Agenda Item #5

Application 2024-24-CA

Summary of Request:

Demolish existing one-story frame single-family residence.

Site Photos - Submitted by applicant - 406 Wisconsin Avenue

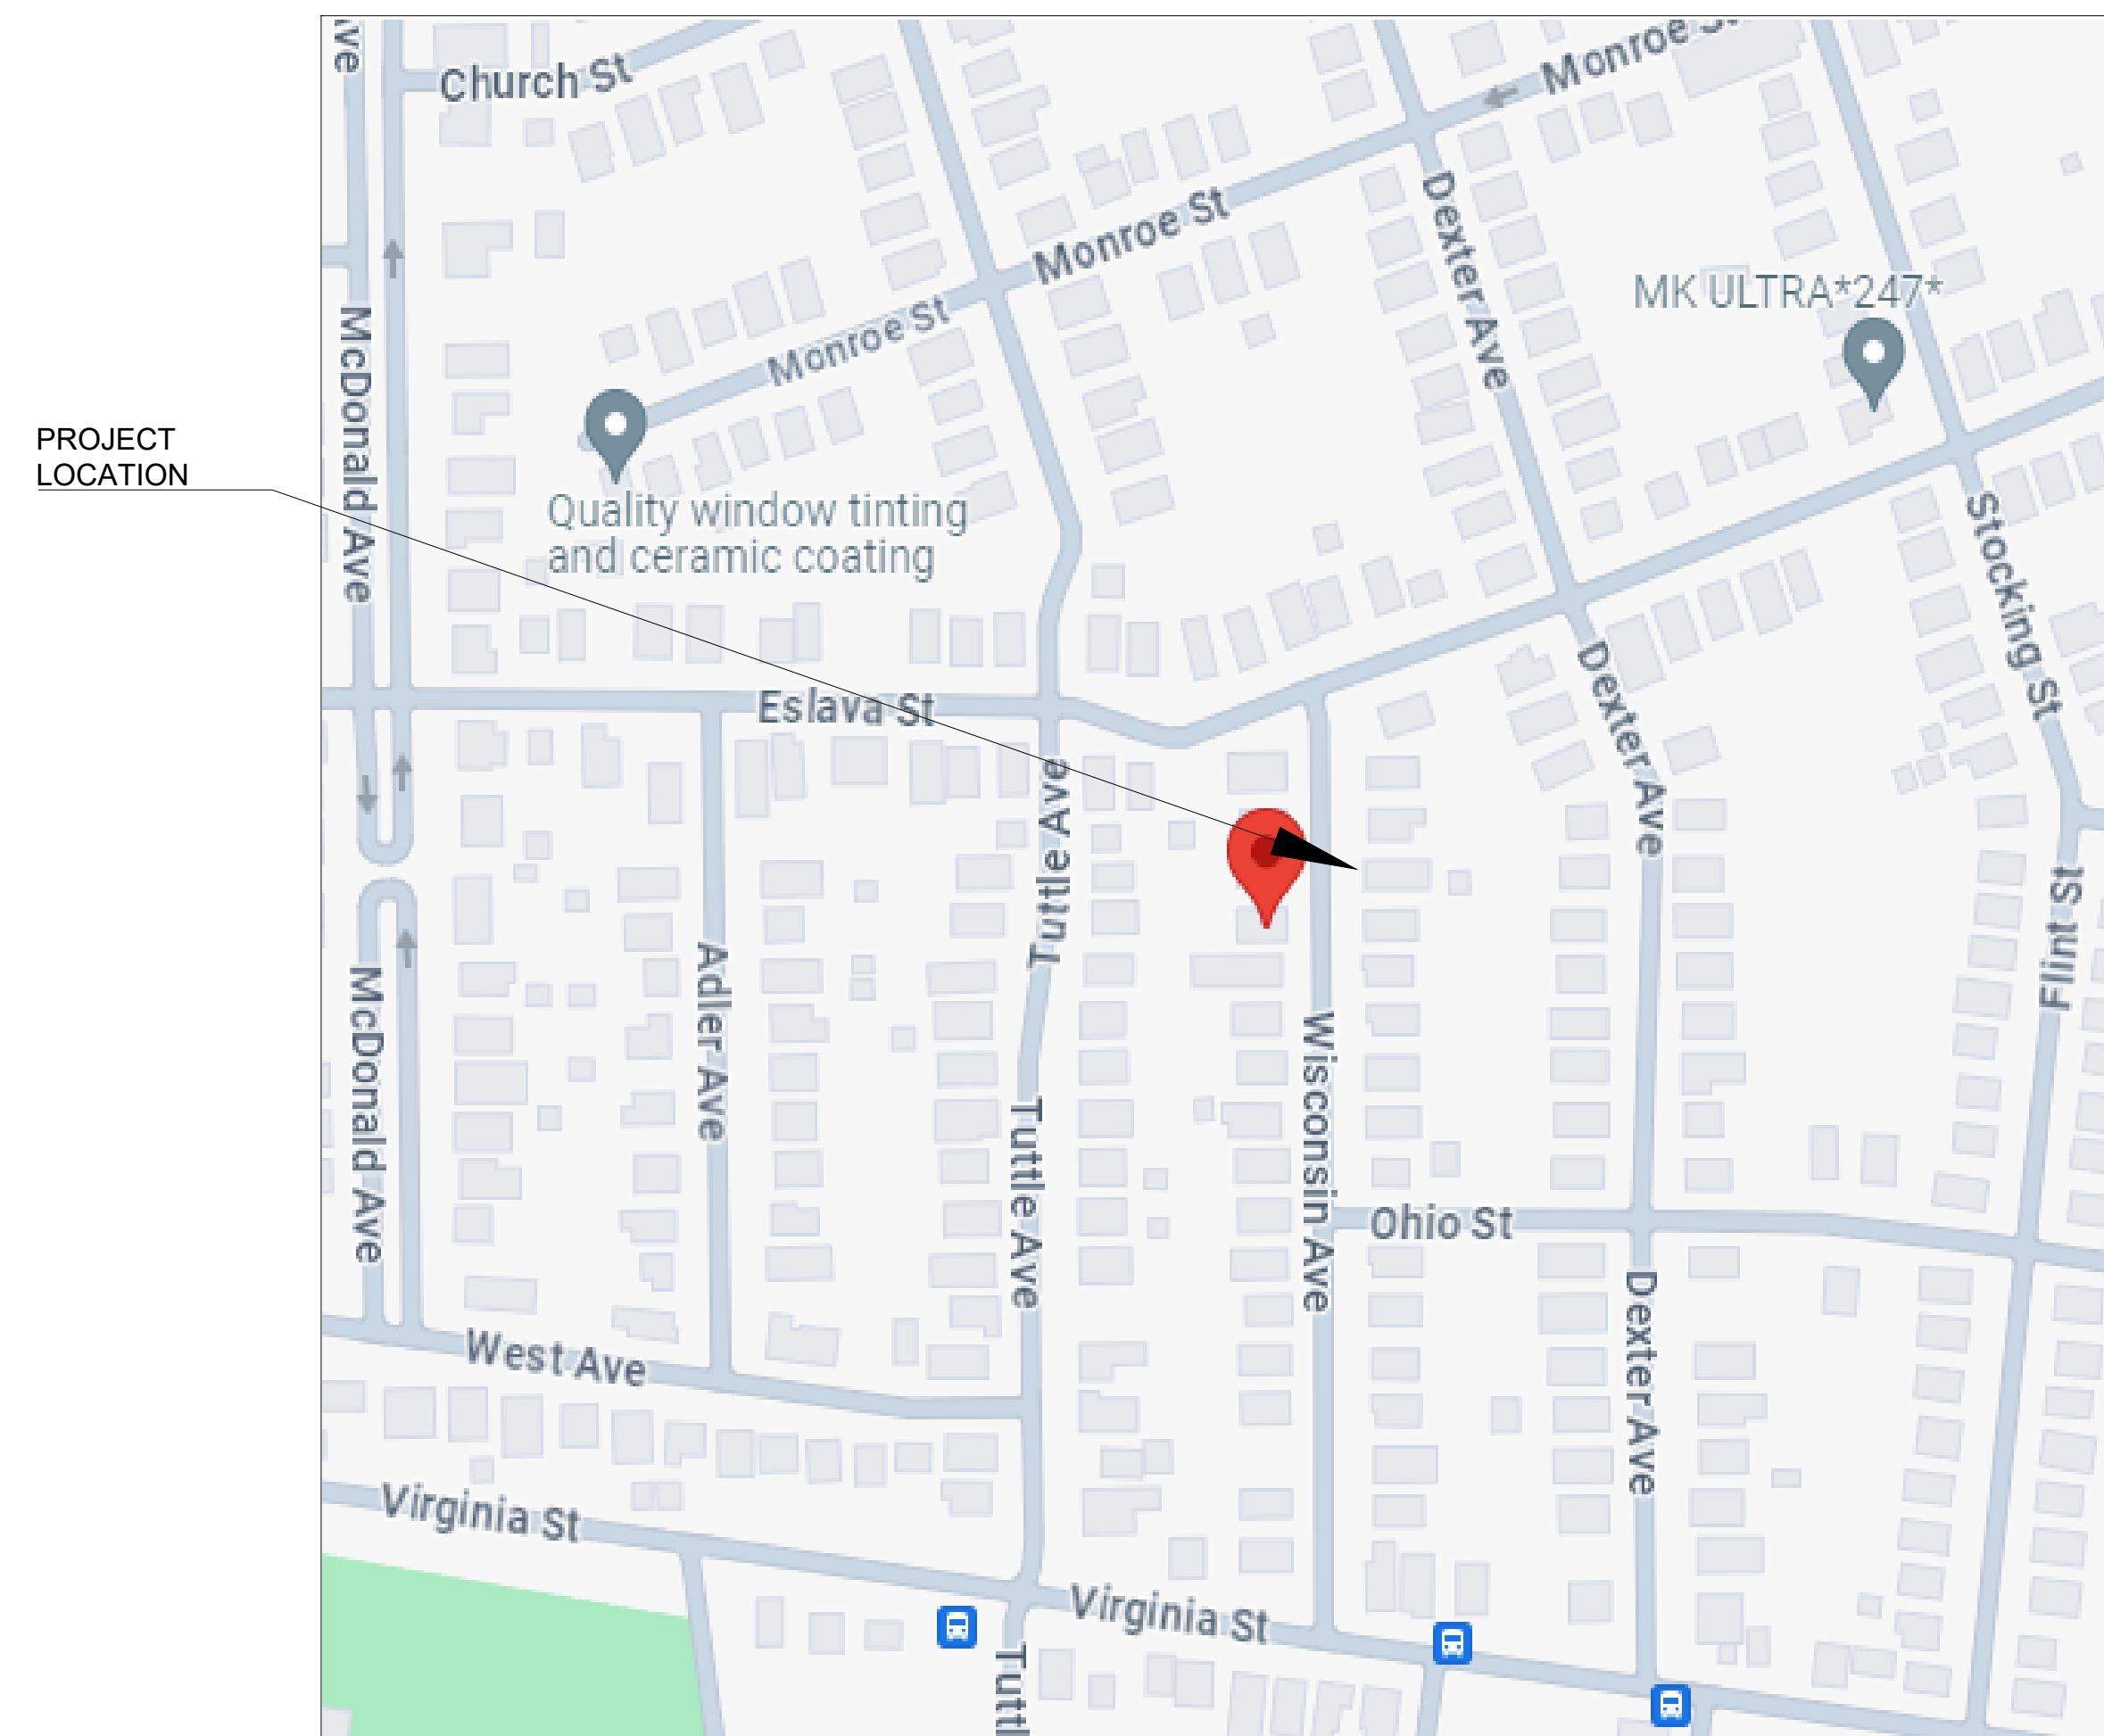
Per the *Guidelines*, "the condition of the structure in question" should be considered. "Demolition may be more appropriate when a building is deteriorated or in poor condition." In the case of the subject property the building has sustained some superficial deterioration including areas of rotten or missing siding, along with damaged roof rafters and mortar corrosion between brick courses on foundation piers. There is some visual evidence of sunken piers signifying settling of the structure over time, which is common for historic homes in this region. A structural assessment report was submitted with the application which notes areas of deficiencies. The noted items in the report are typical of an aging building and do not indicate that the building cannot be rehabilitated or that it is a public hazard.

SITE PLAN

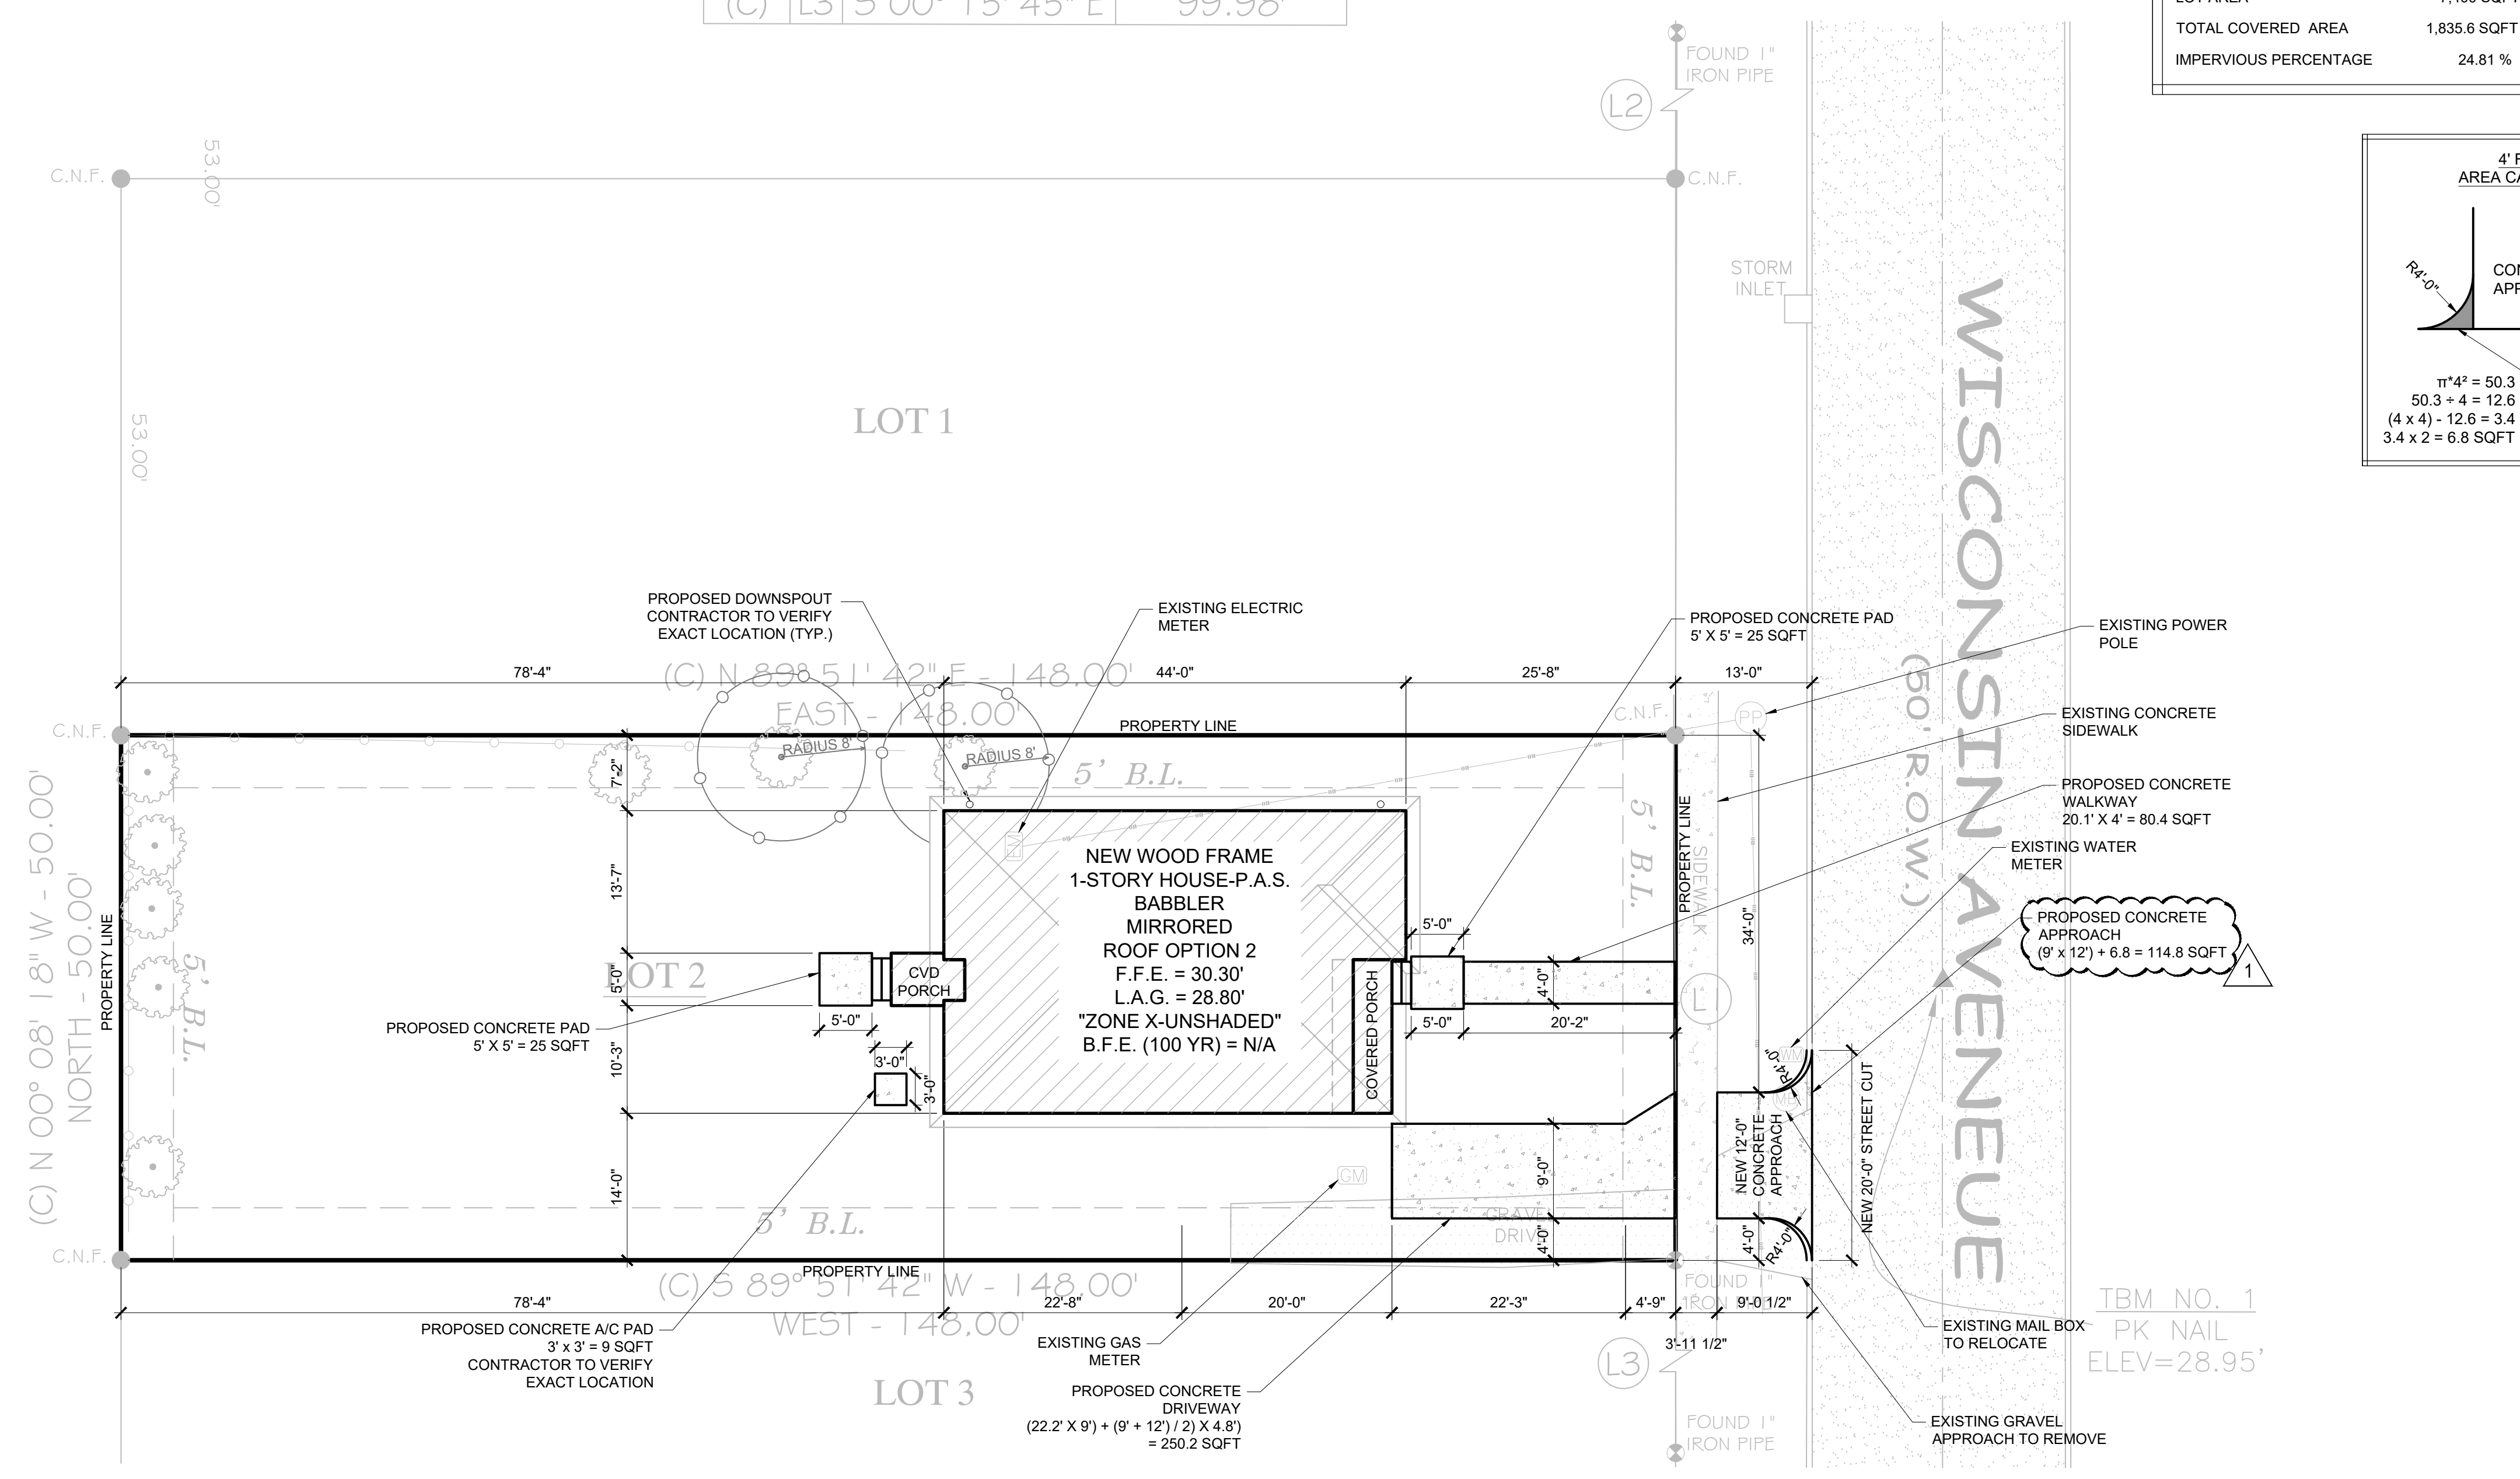
The *Design Review Guidelines* provide directives for new construction within Mobile's historic districts. Front yard setbacks of a new residential structure should fall within the range established on the street. The new structure proposed for 406 Wisconsin would sit similarly on the lot as the existing house and the, With a proposed front setback of 25'-2" and side yard setbacks of 7'-2" and 14'-0", the proposed structure would sit similarly on the lot as the existing historic house and would also fall within the established range that occurs on surrounding lots. (6.34, 6.35)

The proposed installation of a concrete walkway connecting the existing sidewalk to the façade is a practice directed by the *Guidelines*. However, the 5' x 5' concrete pad proposed for the west end of the walkway is not a common feature seen at surrounding historic properties. The replacement of the existing driveway appropriately provides parking to the side and rear of the site, as called for in the *Guidelines*. (10.5, 10.7)
